Product Change Notice

Sub: Packaging changes for FCSL110 and FCSL150 series. Effective Immediately

Old:

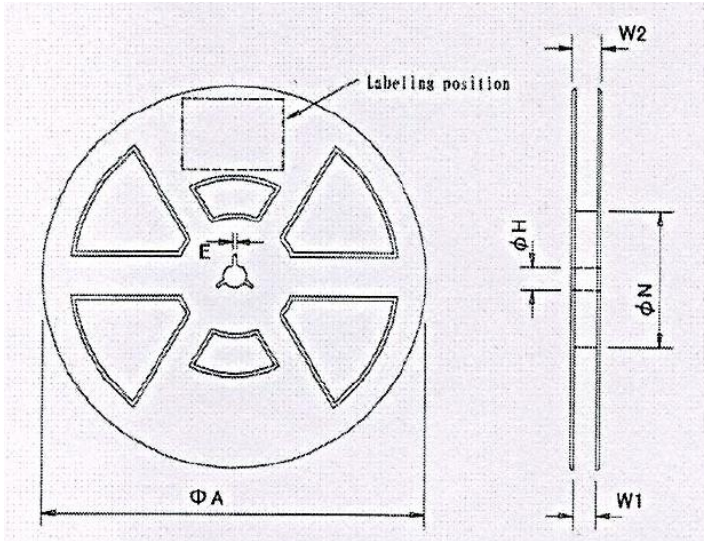
Ohmite announces dimensional changes to the reels of FCSL110 and FCSL150 series parts. The "A" dimension of the current reels are 330mm \pm 2mm. This dimension will change to 180mm \pm 2mm. The "N" dimension will change from 100mm \pm 1mm to 21mm \pm 0.8mm. Existing stock of the old reel sizes will be shipped until stock is exhausted. Parts are stocked by value and wattage. There may be instances when two part numbers may arrive with two reel sizes due to stock demands. Old and New reel dimensions are listed below for reference.

Dimensions (mm)
ΦA	180±2.0
ΦH	13±0.2
E	2.0±0.5
ΦN	21±0.8
W1	25.4±1.0
W2	29.4±1.0
